**Re: Headquarters Road over Tincum Creek Replacement Project
Permit No. E0901120-026, Pennsylvania Department of Transportation**

The Delaware Riverkeeper Network and Maya van Rossum, the Delaware Riverkeeper, submit the following comment in opposition to the Joint Permit Application (“Application”) submitted by Pennsylvania Department of Transportation (“PennDOT”) Engineering District 06. PennDOT proposes to demolish the historically invaluable Headquarters Road Bridge (also known as Sheephole Bridge or Burnt Mill Bridge) along Tincum Creek located in the Ridge Valley Rural Historic District in Tincum Township, Bucks County, and construct a modern two-lane bridge in its place (hereinafter, the “Project”).

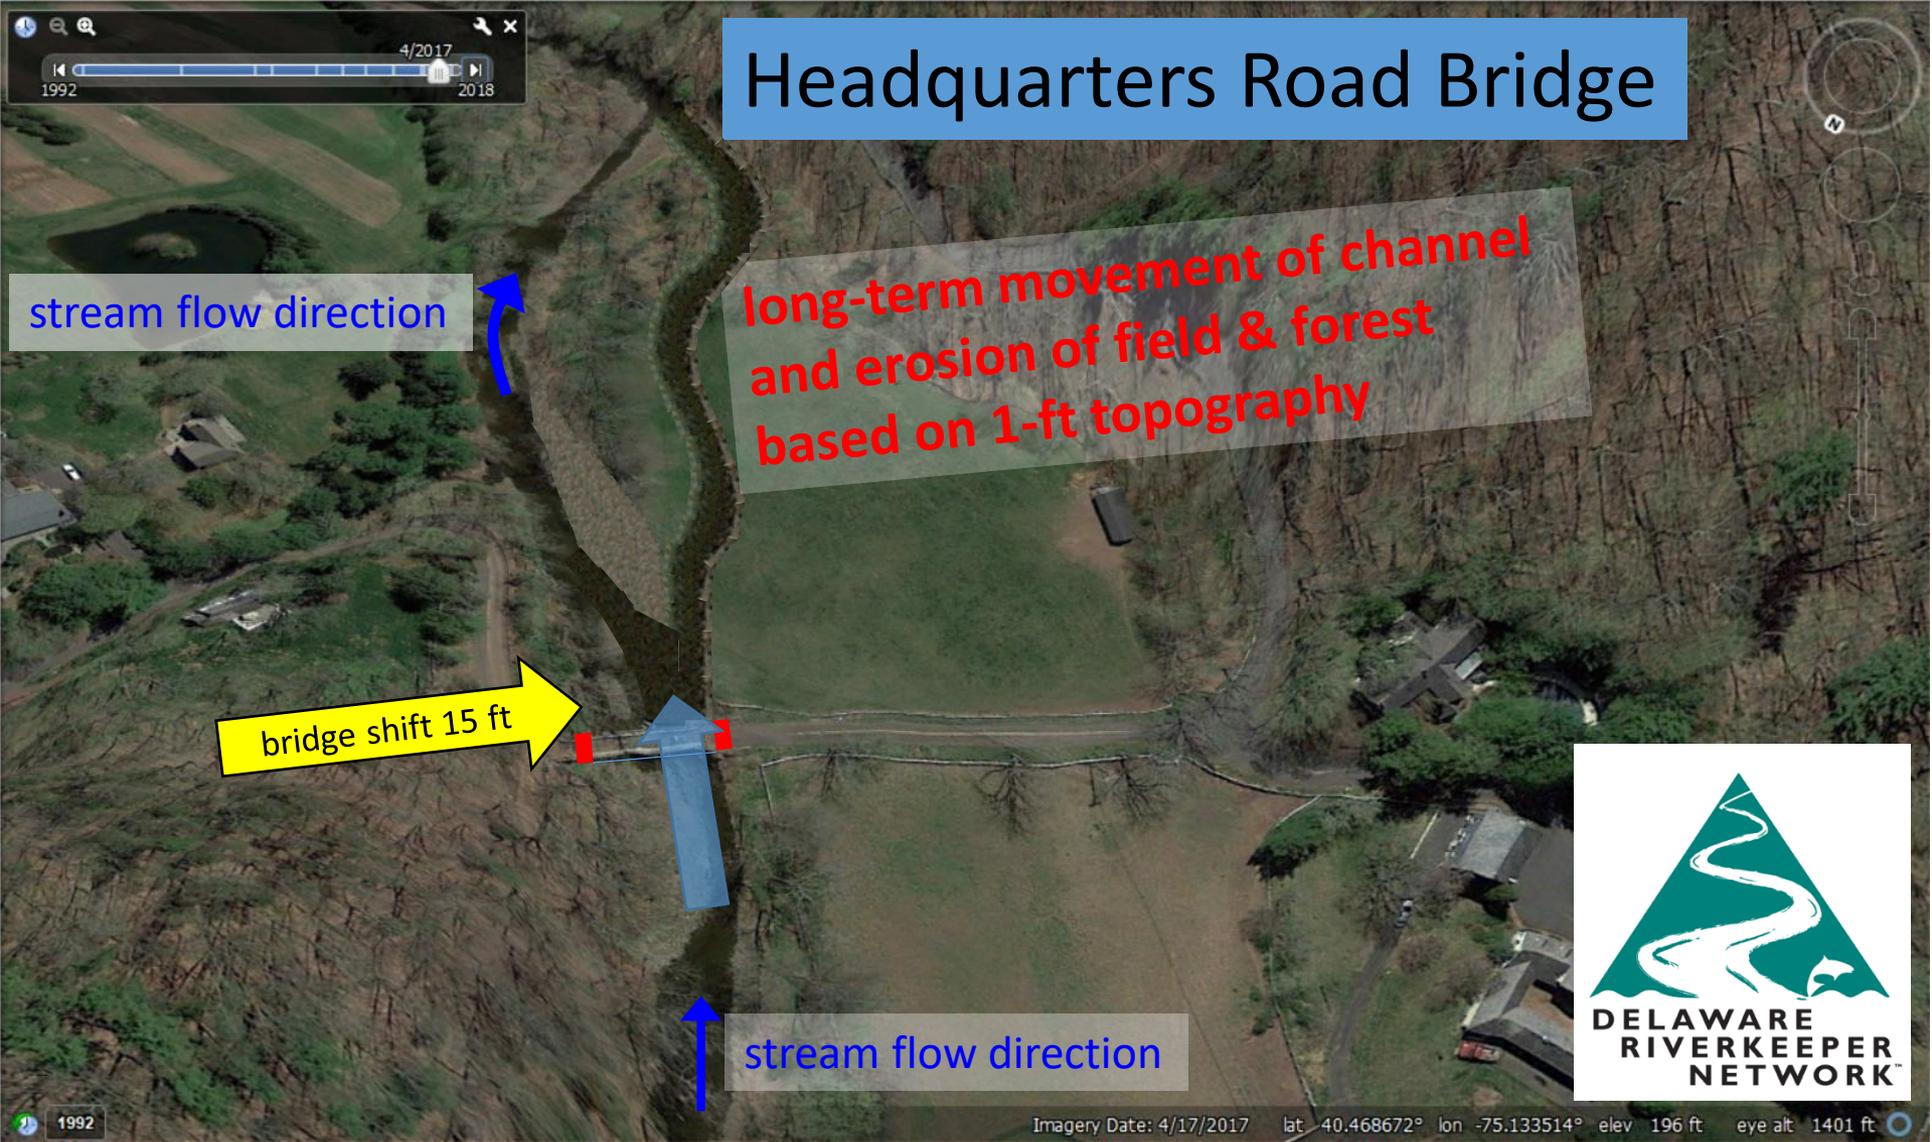
3. Stream immediately erodes downstream stream banks & tree line, and eliminates riparian corridor
